**WHITE LAKE TOWNSHIP  
INTER-OFFICE MEMORANDUM  
COMMUNITY DEVELOPMENT DEPARTMENT**

**SUBJECT: Taco Bell  
Preliminary Site Plan Approval**  
Property described as parcel number 12-20-276-036, located at the northeast corner of Highland Road (M-59) and Bogie Lake Road, consisting of approximately 1.07 acres, currently zoned (PB) Planned Business District.

**RE: Taco Bell Preliminary Site Plan Review – 1<sup>st</sup> Review**

**Subject:** Taco Bell  
Preliminary Site Plan Review #2  
Zoned: Planned Business (PB) District

**FIRE TRUCK ACCESS PLAN**  
SCALE: 1" = 20'

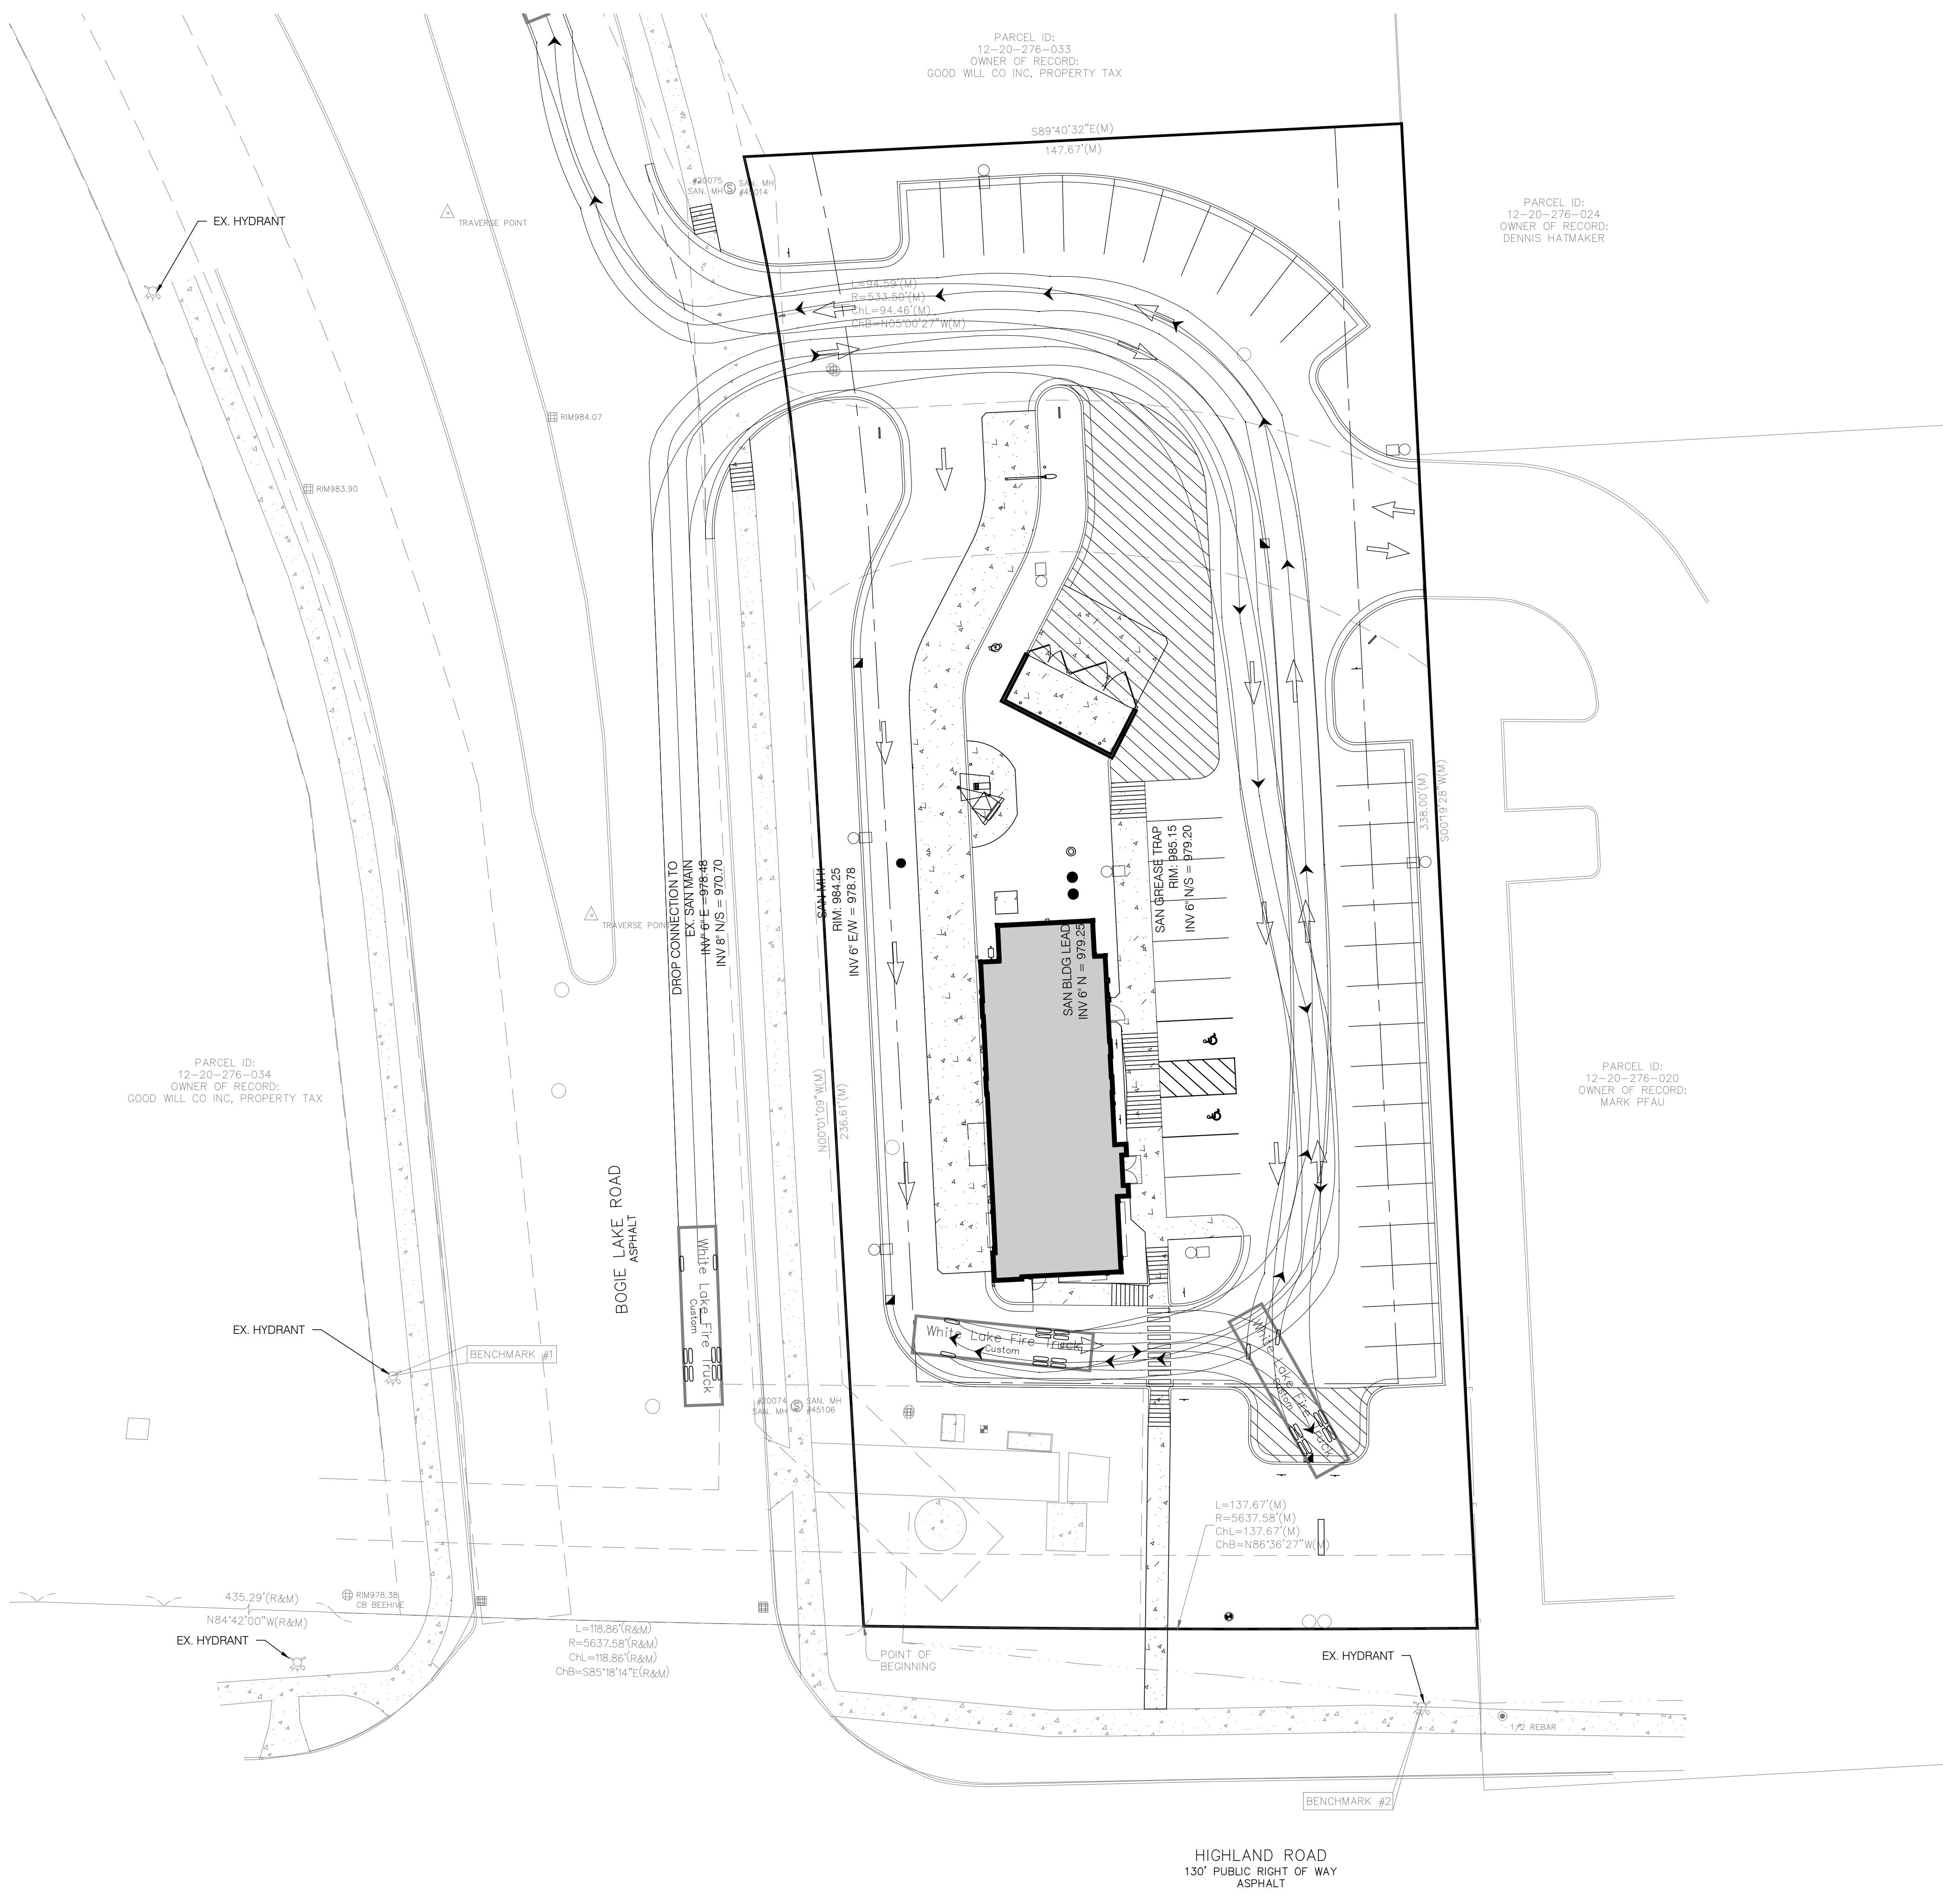
4. Plan sheet C3.1 shows the turning radius profile for a 40' long fire truck and the path necessary for navigating the site. Please note the plans indicate the truck would be required to turn around by backing into the hatched area on the south side of the parking lot. We defer further comment to the Township Fire Department.

DATE: 08/02/2021  
SCALE: 1" = 20'  
PROJECT NO: 18-00000  
C5.0

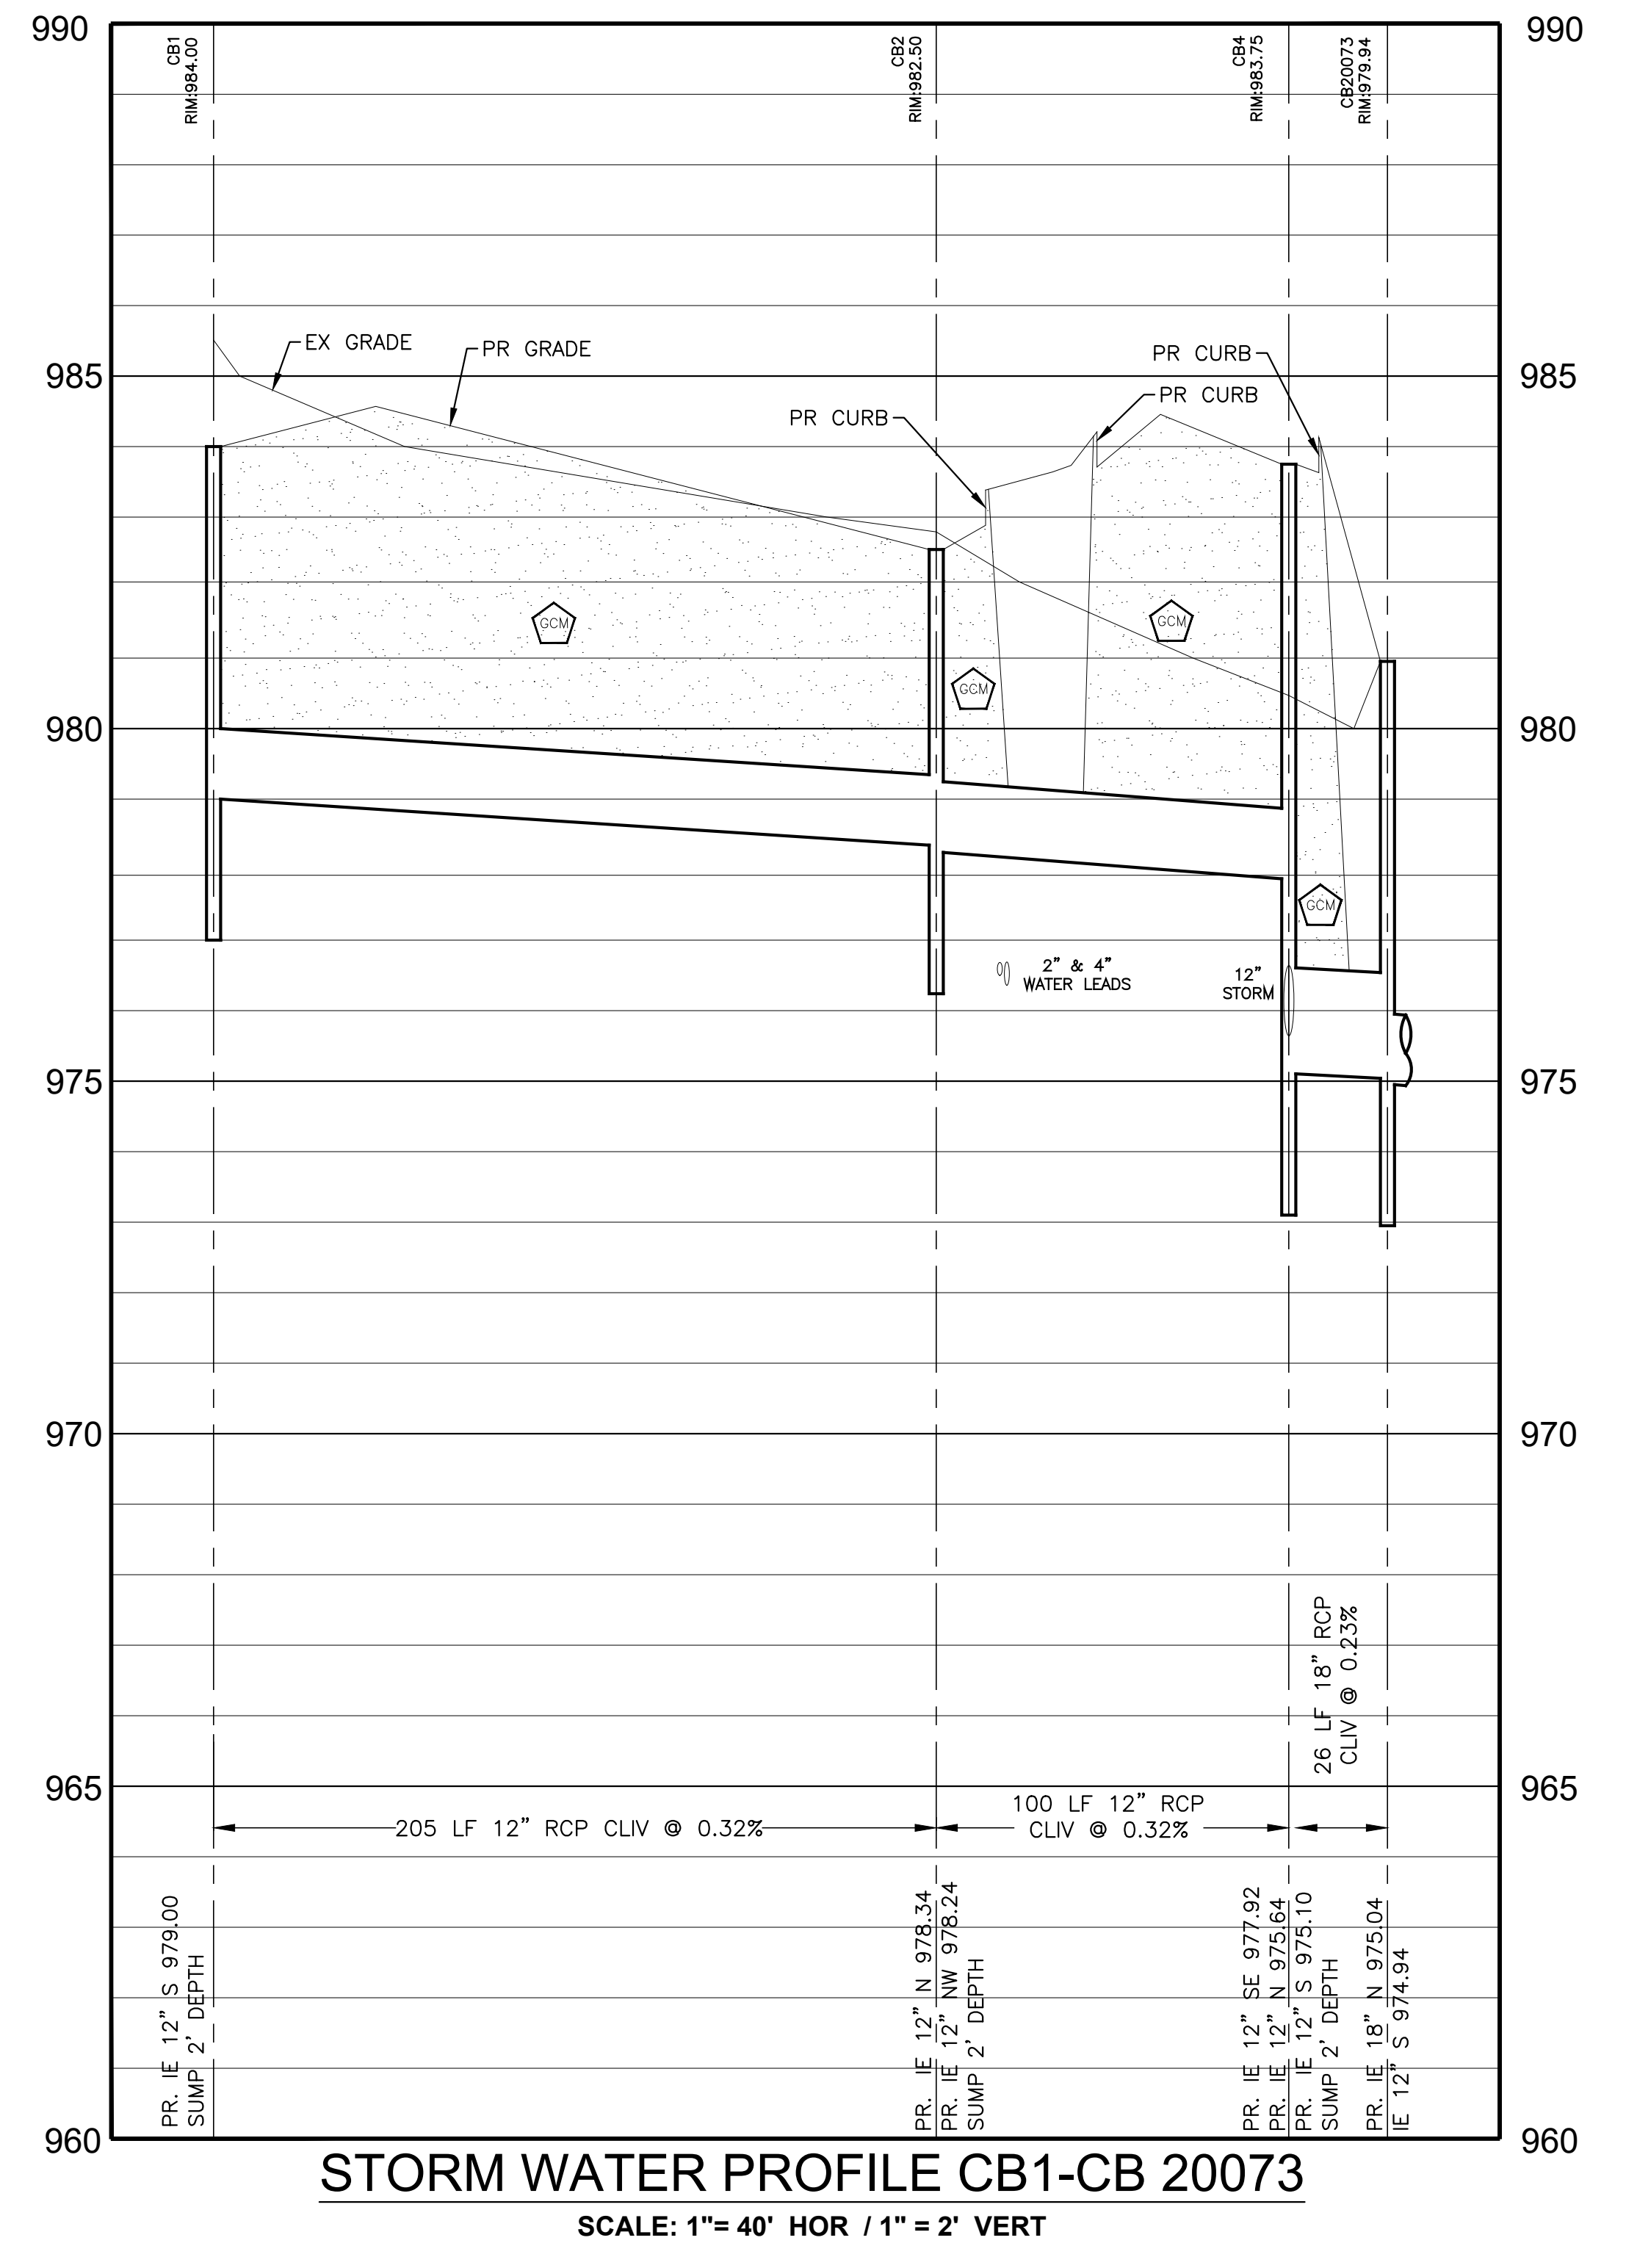
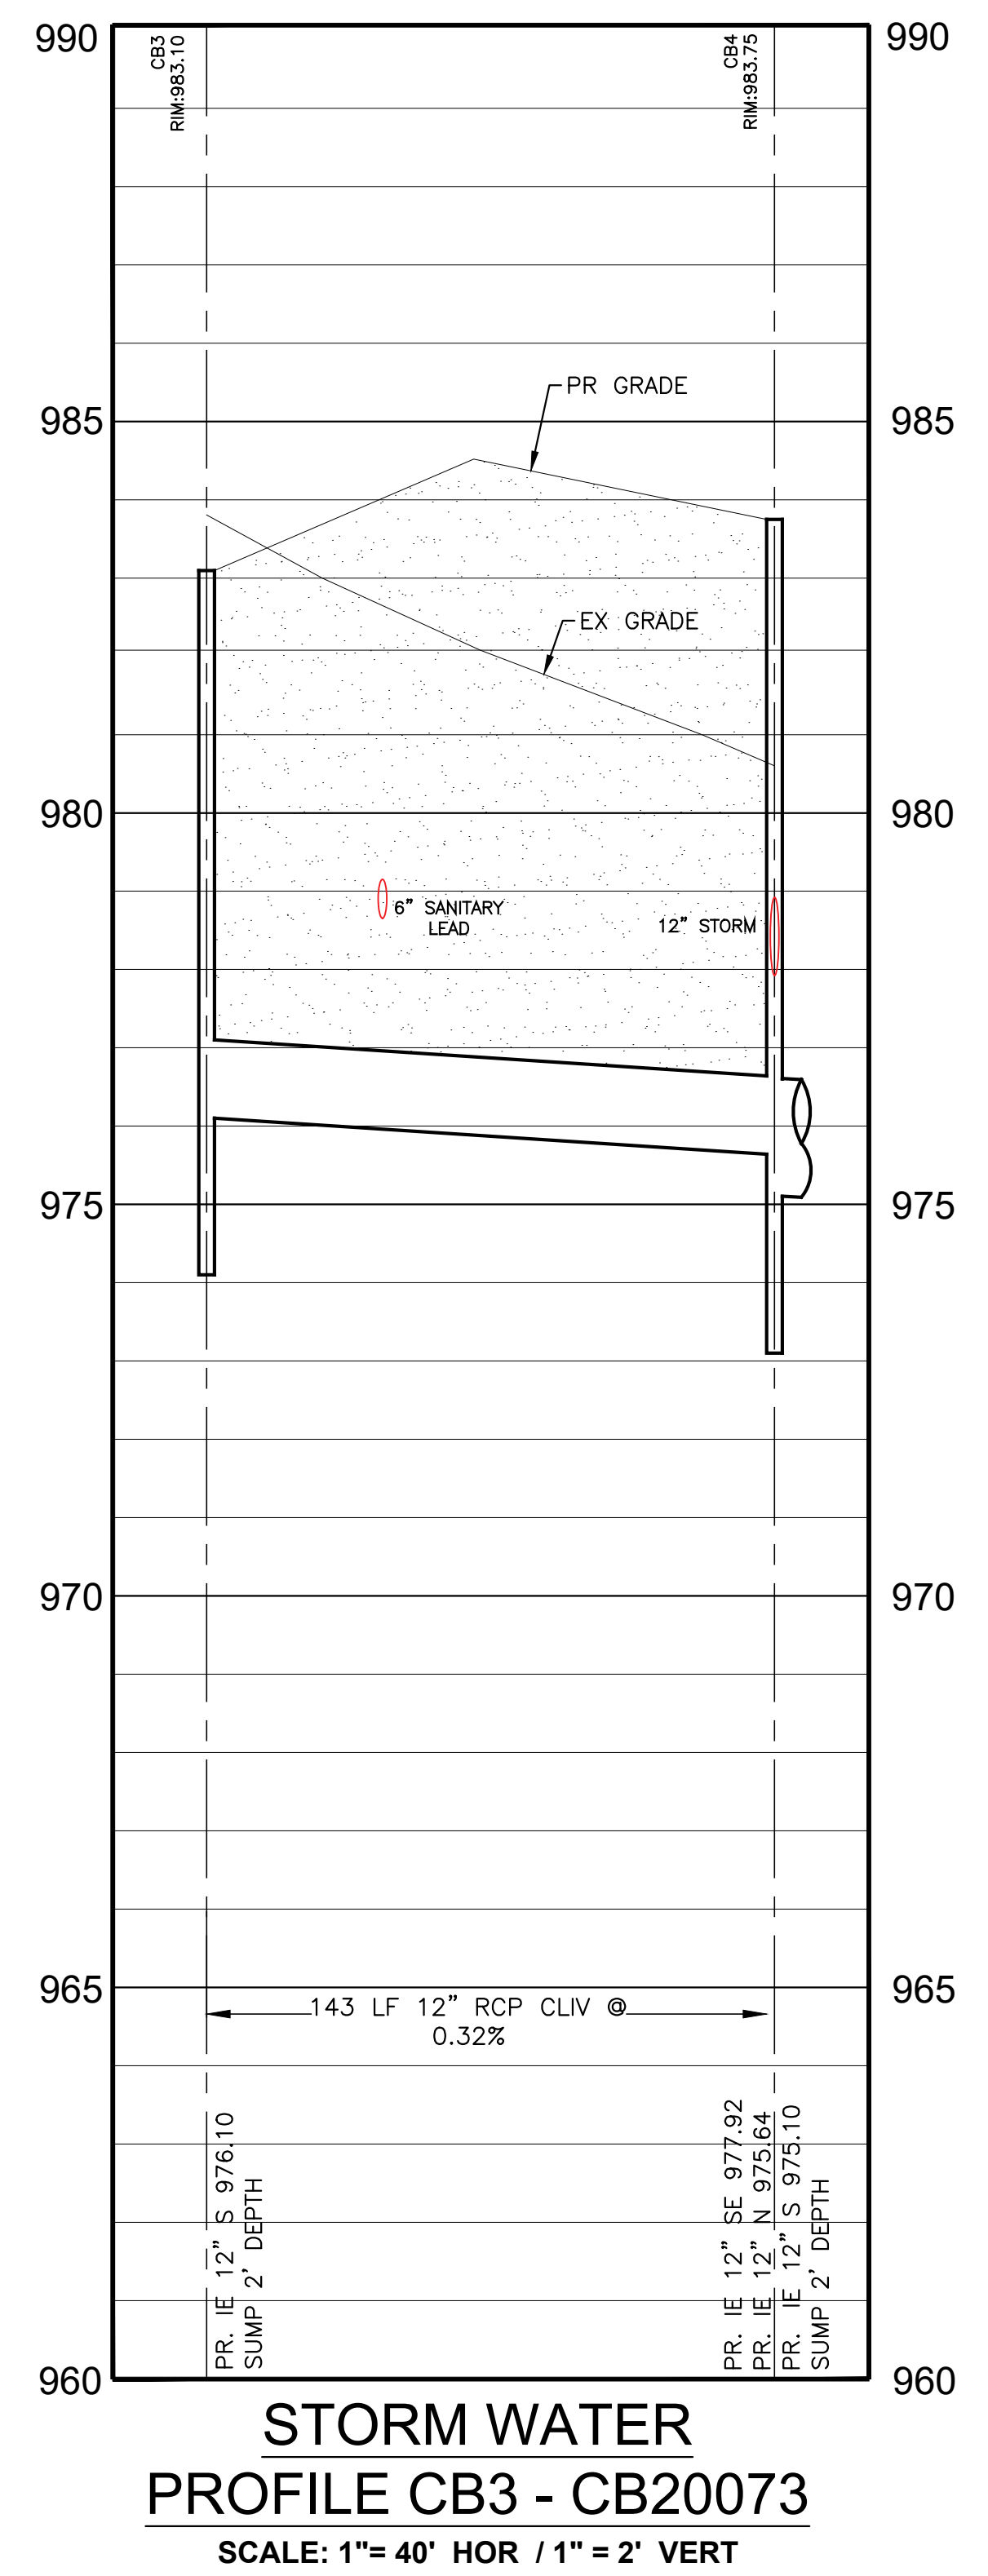
Note 11 on sheet C5.0 indicates that the Township shall connect services 2 inch and smaller. While the Township can provide the connection, an 20 % admin fee will be charged per ordinance. It will usually be less expensive for the developer to use their own properly licensed and bonded contractor for the connection which we will inspect.
